RAI Volume 3, Chapter 2.2.1.2.1, Fifth Set, Number 2:

For the FEPs listed below; clarify the rationale to exclude the FEP on the basis of low probability.

Response Tracking Number: 00356-00-00

Figure 1. Representative Event Tree

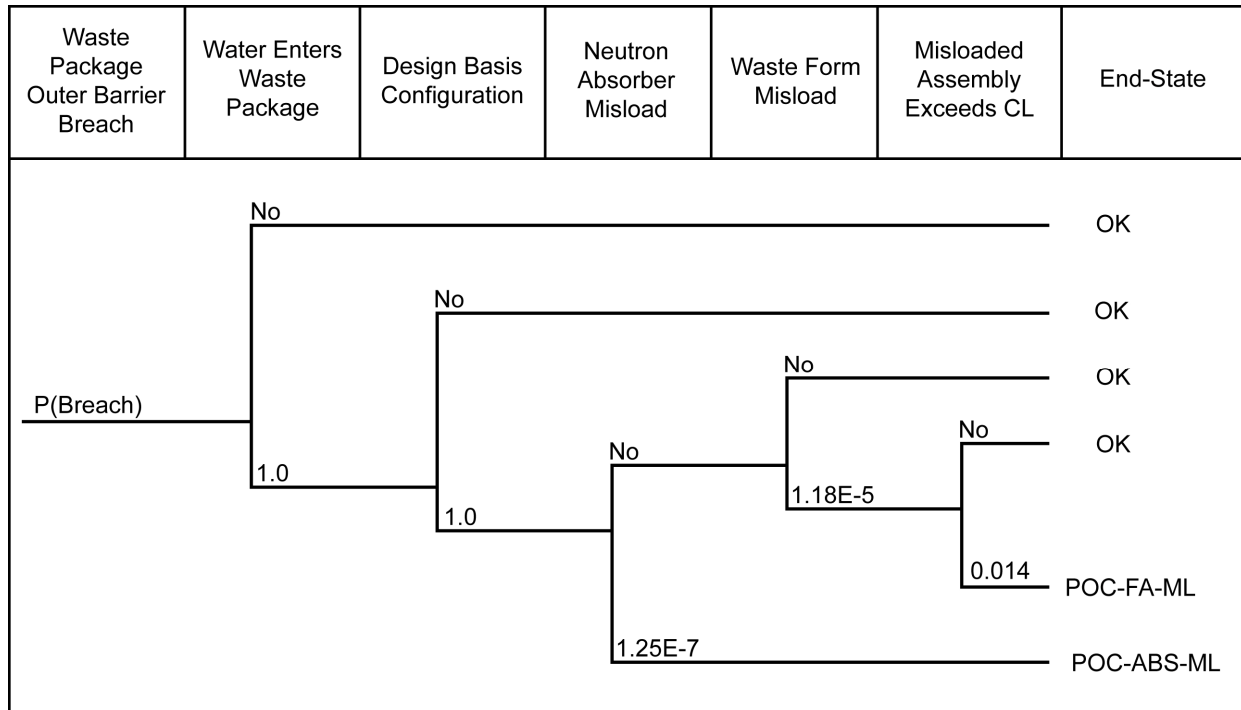
In light of SAR Section 2.2.1.4.1.1.1, Figure 2.2-4, and the description provided in SNL (2008b, Section 1), provide the justification, including the ranges of parameters, used to determine that the two sequences of events [i.e., (1) improper manufacturing, resulting in the absence and/or loss of efficacy of the neutron absorber material, and (2) improper loading of fuel assemblies] are the dominant event sequences, and the bases for screening the other event sequences. This information is needed to assess compliance with 10 CFR 63.114.

Basis: SAR Section 2.2.1.4.1.1.1 states that the criticality potential evaluation begins with the identification of applicable configuration classes and describes how configuration classes are used for this evaluation. SAR Figure 2.2-4 and the information used to screen out the individual feature, event, and process (SNL, 2008a) appear to be inconsistent. SAR Section 2.2.1.4.1.1.1 and Figure 2.2-4, which describe the disposal criticality analysis methodology approach, seem to indicate that quantification is to be used in waste form configuration class evaluations yet SNL (2008a), and references cited therein (SNL, 2008b and BSC, 2004), only discuss qualitative analyses.

The process used as described in SAR Figure 2.2-4 does not require full quantification of the probability of criticality to be calculated for screening out FEPs. The first decision point identified as diamond 1 in SAR Figure 2.2-4 represents a predetermined probability screening criterion defined to be well below (a minimum of two orders of magnitude) the 10 CFR 63.114(d) regulatory criterion. The wording for this screening criterion has been modified for clarity in *Screening Analysis of Criticality Features, Events, and Processes for License Application* (SNL 2008b) to the *a priori* screening criterion. This criterion is used to screen from further consideration configuration classes that have an insignificant contribution to the total probability of a criticality occurring in the repository during the 10,000-year period following closure of the repository, where “insignificant” means an evaluation that included the configuration class would not change the overall result.

In order to simplify and bound the probability of criticality evaluations, all events that cause waste package breach are considered to result in formation of the design basis configuration (see representative event tree in Figure 1). Thus, the probability of forming the design basis configuration given a breach of the waste package is set to a probability of one, which is bounding for the event sequence calculation and makes the configuration class probability equal the waste package breach probability. Therefore, when considering the criticality FEPs, the initiating event (i.e., rockfall, early-failure, seismic, and igneous) probabilities that result in breaching one or more packages in the repository are compared against the *a priori* screening criterion (box 1).

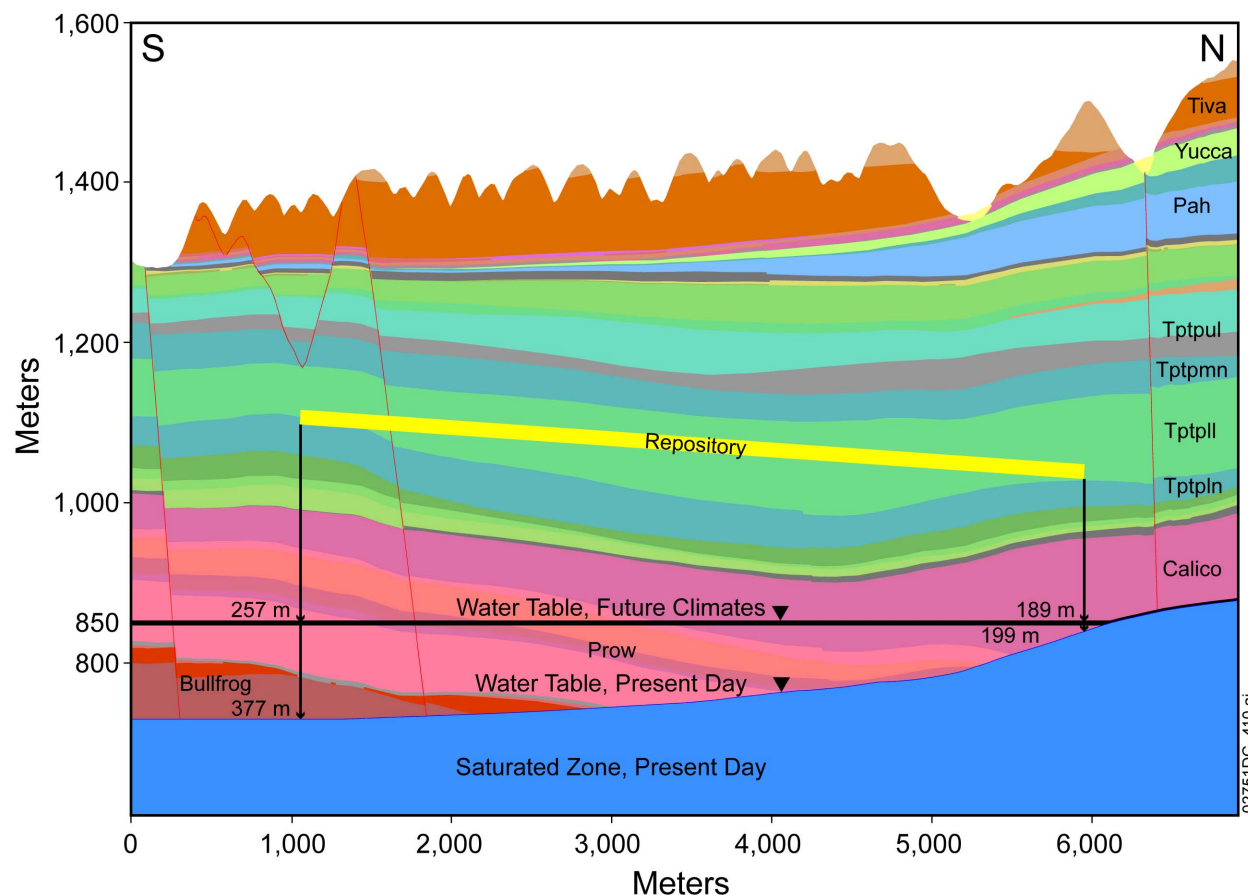
1. Most of the dose estimates reported in the SAR show confidence bands including median and mean doses. Clarification is needed on whether the safety analysis report conforms with 10 CFR 63.303 regarding the use of the arithmetic mean of projected doses beyond 10,000 years.

SAR Figure 2.4-11 shows the distribution of expected annual dose for the human intrusion modeling case. The value of the Human Intrusion Standard shown on SAR Figure 2.4-11 is also

from the proposed rule (350 mrem). The red curve on this figure is the arithmetic mean specified at 10 CFR 63.303. The peak value of the mean occurs within a few thousand years after the intrusion and the peak value is 0.013 mrem (SNL 2008a, Section 8.1.3.2[a]).

Figure 1. Seepage Rate as a Function of Percolation Flux

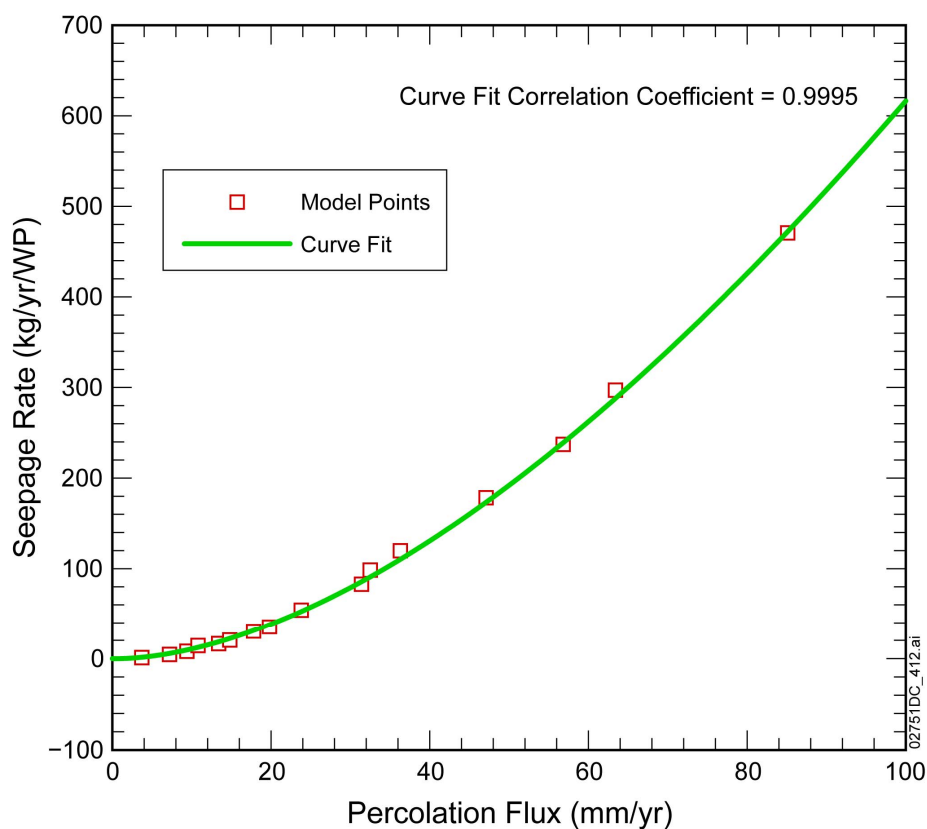
Provide a technical basis for exclusion of FEP 2.2.07.05.0A that addresses: (1) the observation that temporally varying percolation fluxes may induce time-averaged seepage that is larger than would occur with the same average flux applied at a steady rate; (2) temperature and tritium field observations that suggest episodic flow may be prevalent at Yucca Mountain, at least in scattered locations; and (3) why multi-decadal climate fluctuations necessarily have a negligible effect on performance when percolation fluctuations demonstrably may result in a systematic increase in seepage. This information is needed to evaluate compliance with 10 CFR 63.114.

Basis: Depending on the timing of the fluctuations, temporally varying percolation fluxes may induce time-averaged seepage that is larger than would occur with the same average flux applied at a steady rate. For example, DOE (2009, RAI 3.2.2.1.1-002, Figure 1-1) provides an illustrative example with mean seepage 50 percent larger under variable percolation fluxes than under the equivalent steady percolation flux.

If seepage into drifts is assumed to be a quasi-steady process under transient percolation flux conditions, the variation in seepage behavior for different steady percolation fluxes may be used to evaluate differences in seepage rate into drifts for episodic percolation flux conditions as compared with the equivalent steady percolation flux. “Equivalent steady percolation flux” is defined as the time-weighted average of the series of spatially averaged percolation fluxes defining the episodic flow process. In this response, spatially averaged percolation flux over the repository footprint is referred to as “percolation flux.”

The model points and curve fit show that the seepage rate curve is convex over the range of percolation fluxes displayed in Figure 1. The asymptotic linear behavior of the seepage rate curve occurs at percolation fluxes in excess of 100 mm/yr.
